Addendum No. 03

File No. 40-39 **Date:** 8/24/2026
DSA Appl. No. 03-125585

Project: **Dana Elementary New Classrooms**
920 W. Tefft Street
Nipomo, CA, 93444
Lucia Mar Unified School District

Pre-Bid RFI's Review

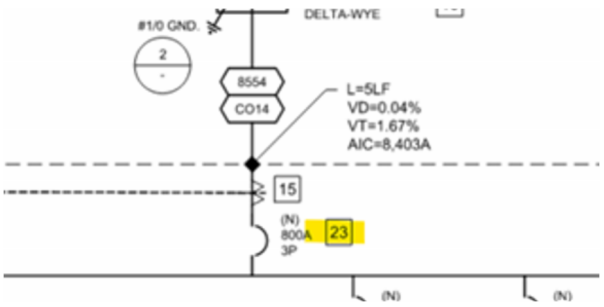
1. Note 15 is shown inside of (N) Distribution panel DP60. Note 15 is for the transformer disconnect.
    a. This appears to be for a ¾" conduit with CT cabling. Please update note.

Reference note has been removed from the CT's as per the image below. Please refer to updated Addendum 03 plans, dated 8/24/26.

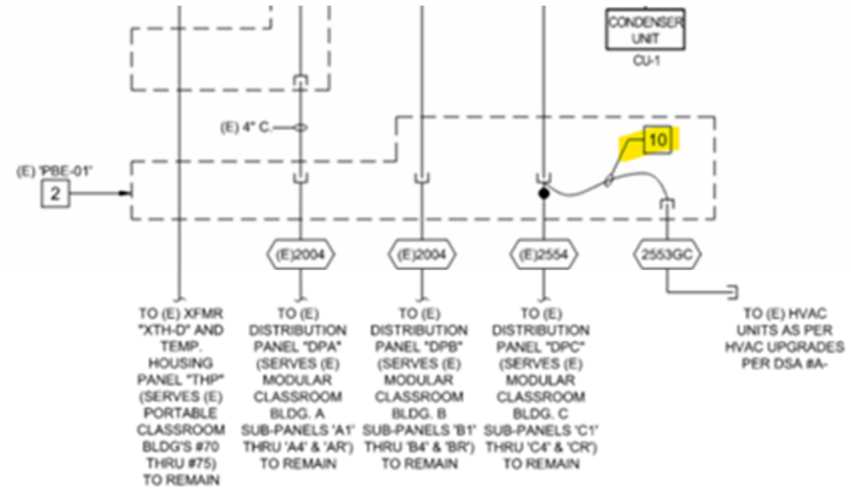
2. There is a note 23 on the single line. There is no note 23 on reference notes.
    a. Please advise.

Reference note 23 is not applicable. Reference note has been removed from main circuit breaker at distribution panelboard 'DP60'. Please refer to updated Addendum 03 plans, dated 8/24/26.

7 ROOM CONTROLLER EMERGENCY BY-PASS
NTS

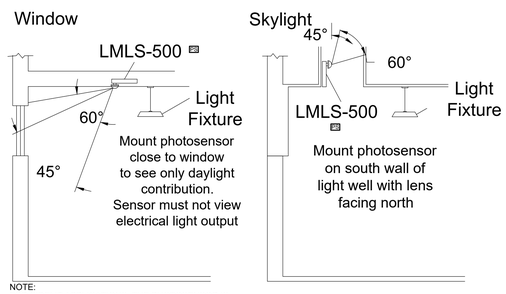
4. Each classroom has a room controller for normal power lighting and a room controller for EM lighting but they are both utilizing the same switches, occupancy sensors, and daylight sensors to control the fixtures in the room. Please confirm how those devices tie into both room controllers.
   Room controller emergency bypass wiring schematic has been added to the plans. Refer to detail 7/ E0.04.

ELECTRICAL SITE PLAN

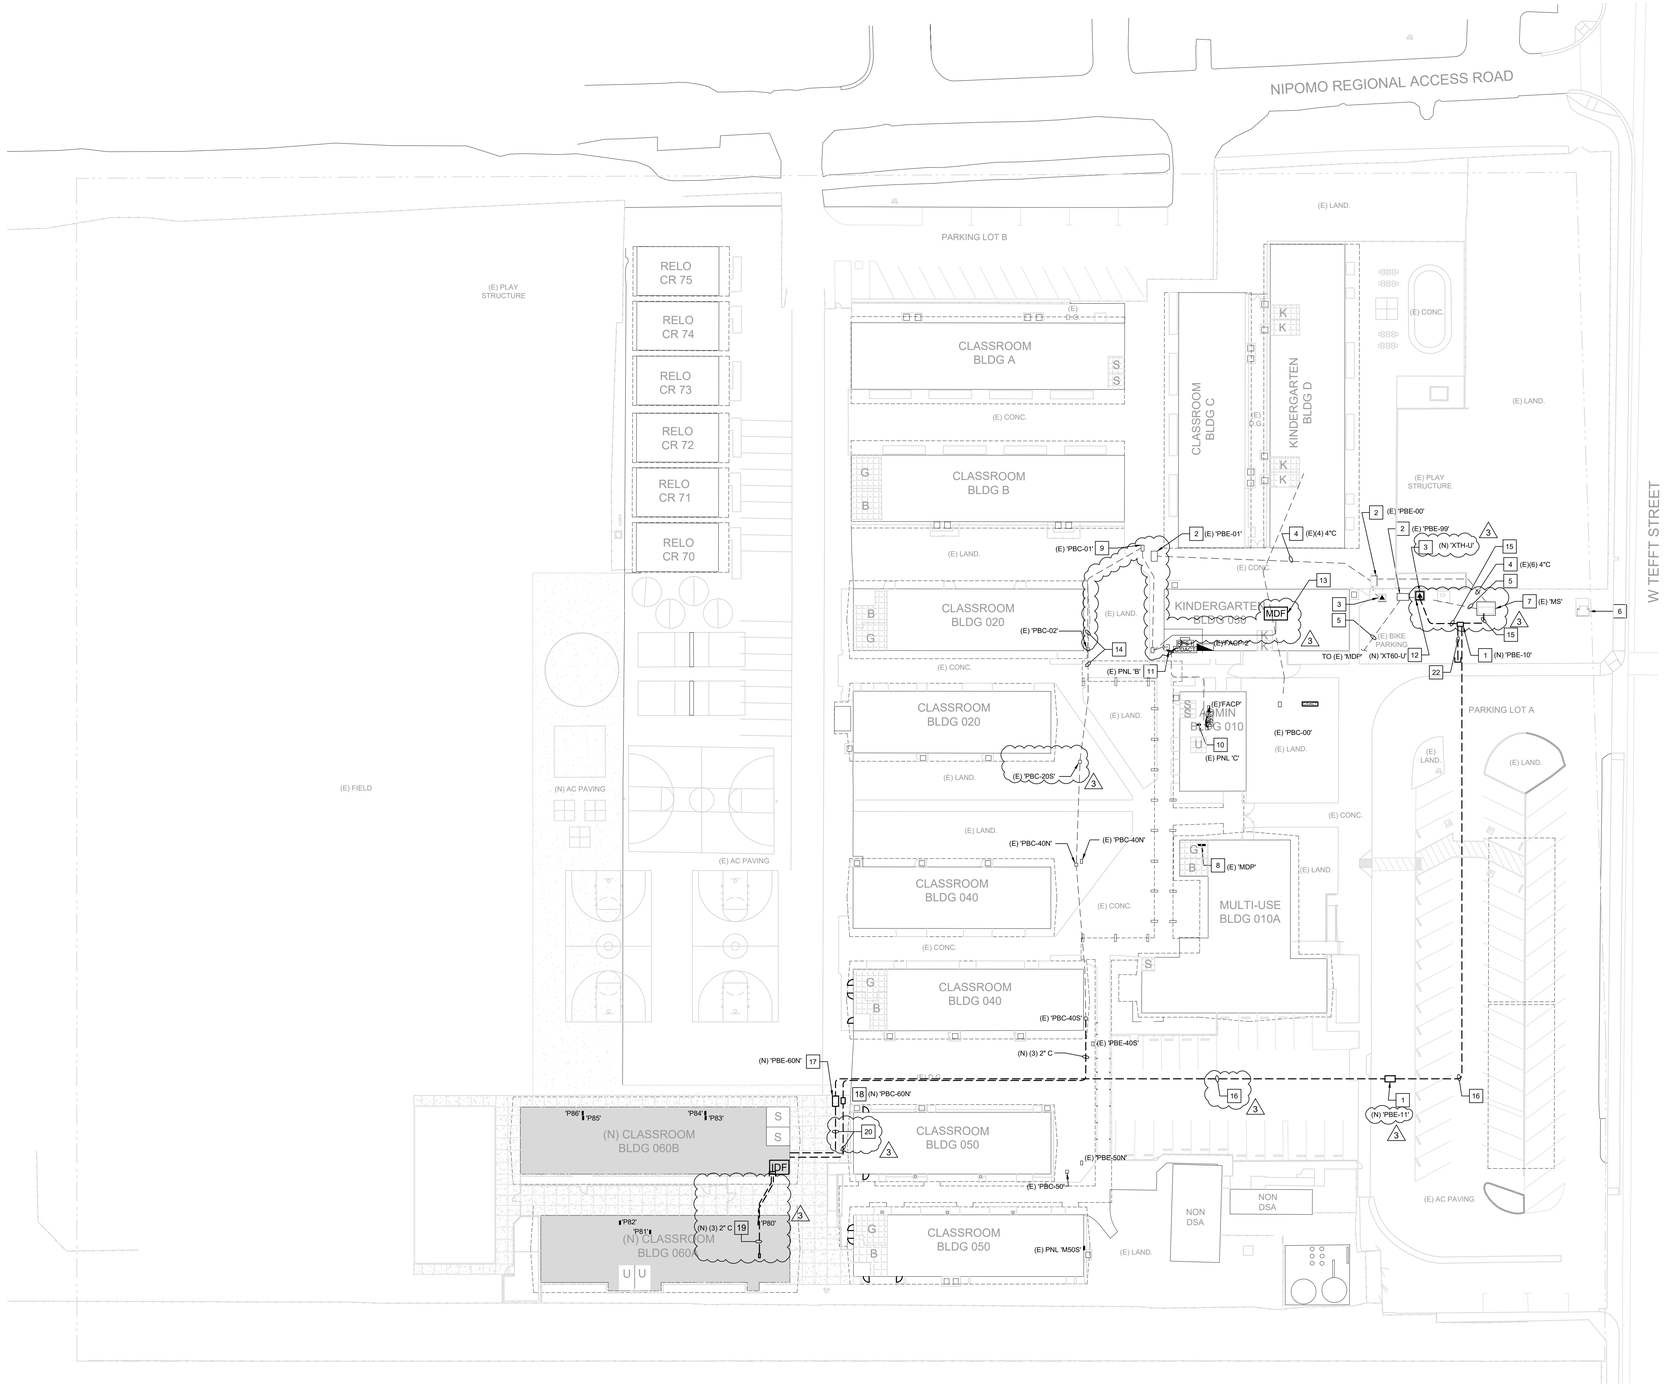
2. Note 21 on Sheet E0.20 calls for a new 11x17 pull box (PBE-60A) for the feeder between Panel DP60 and P80. Can this box be omitted if the maximum allowable bends are not exceeded in this conduit run between the two panels?
   Yes, pullbox has been omitted. Refer to updated plans, Addendum 03, dated 8/24/26.

11. Site plan E0.20 calls for (3) 2" conduits between PBC-40S and (N) PBC-60N but Note 20 calls for (3) 2" COMM conduits and (2) 2" FA conduits between PBC-60N and ELEC/IDF room 83A. Should the (2) FA conduits also extend all the way to PBC-40S?
    No, the (2) 2" conduits for FA shall not be extended to PBC-40S pullbox.

15. The FA riser has a callout to refer to the site plan for existing conduits/raceways to be used for installation of new cabling between buildings but the site plan on E0.20 does not show any existing pathways between the existing FACP in Building 030 and (N) PBC-60N.Please advise the routing of existing conduits and if any new conduits are required for this run.
    Site plan has been updated to show the existing pathway to existing pullbox and up to pullbox (N) PBC-60N. Refer to updated plans.

ELECTRICAL POWER/COMM FLOOR PLAN

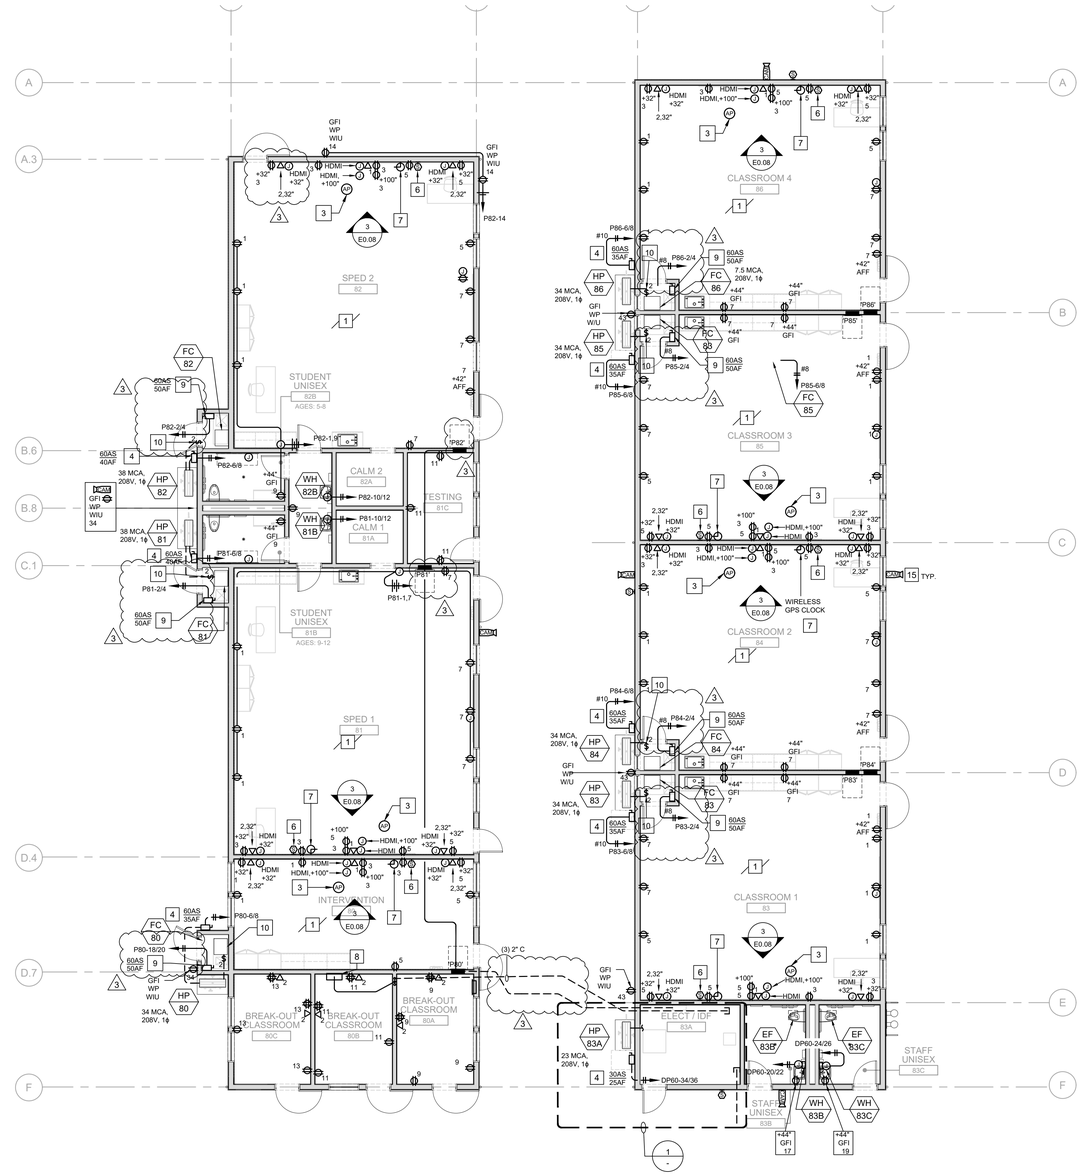
3. Elevation 2A on A7.3 shows a duplex, 2-port data, and HDMI pass-through on the North wall adjacent to the door, but these devices don't appear on Sheet E2.1. Please confirm if they are required.
   Devices are required and have been added to the plans. Refer to Addendum 03 plans.

12. Sheet E2.1 shows (2) 4" conduits between room 83A and (N) box PBC then (3) 2" conduits get installed between (N) PBC and IDF24 at room 80B. Please confirm if both runs should be (3) 2" conduits.
    We will need (3) 2" conduits. Please refer to updated site plan.

PARTIAL CAMPUS COMMUNICATIONS RISER DIAGRAM

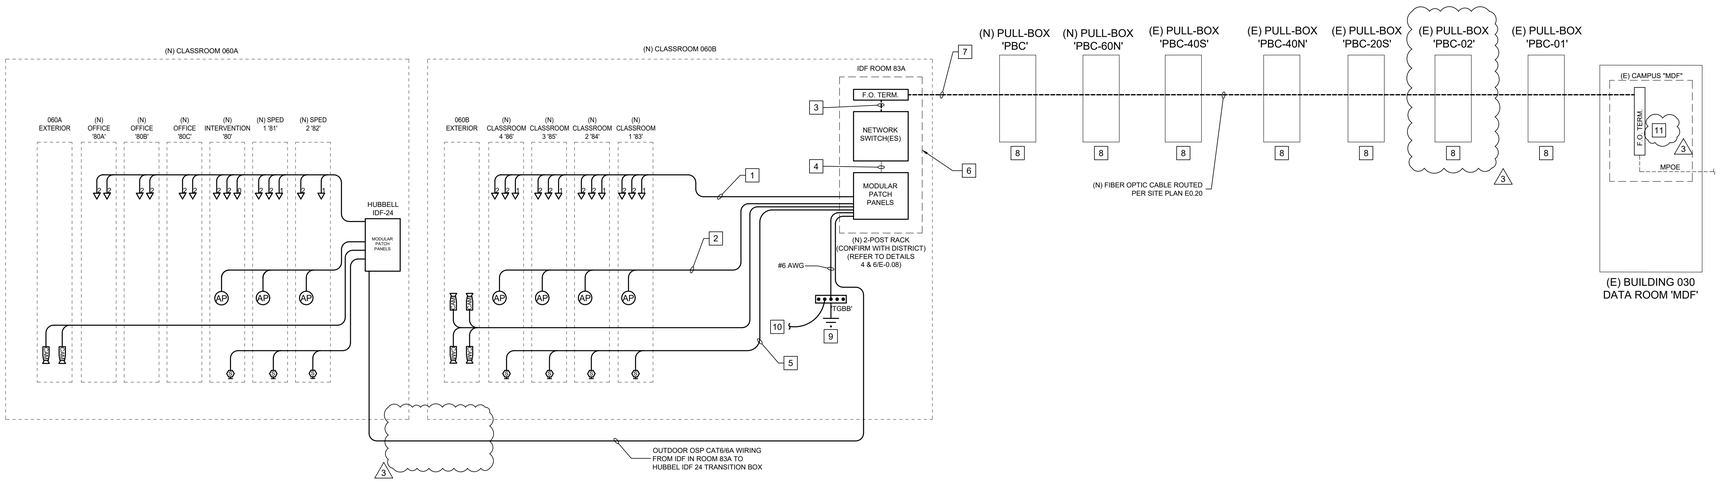
13. The Comm riser on E6.1 shows the new 12-strand fiber routing through (N) Pull-box PBC however PBC is located between the two buildings. Please confirm the fiber routes directly from PBC-60N to the new IDF room.
    Riser has been updated. 12-Strand fiber routes from 'PBC-60N' to new IDF. Refer to updated plans.
14. Is a ground bar or ground connection required at IDF24 in room 80B? If so, can the connection point come from the ground bus in Panel P80 or does it need to come from the main Telecom ground bar in Room 83A in the other building.
    Refer to updated reference note #8 for grounding requirements. Ground will be required and will route back to panelboard 'P80'.
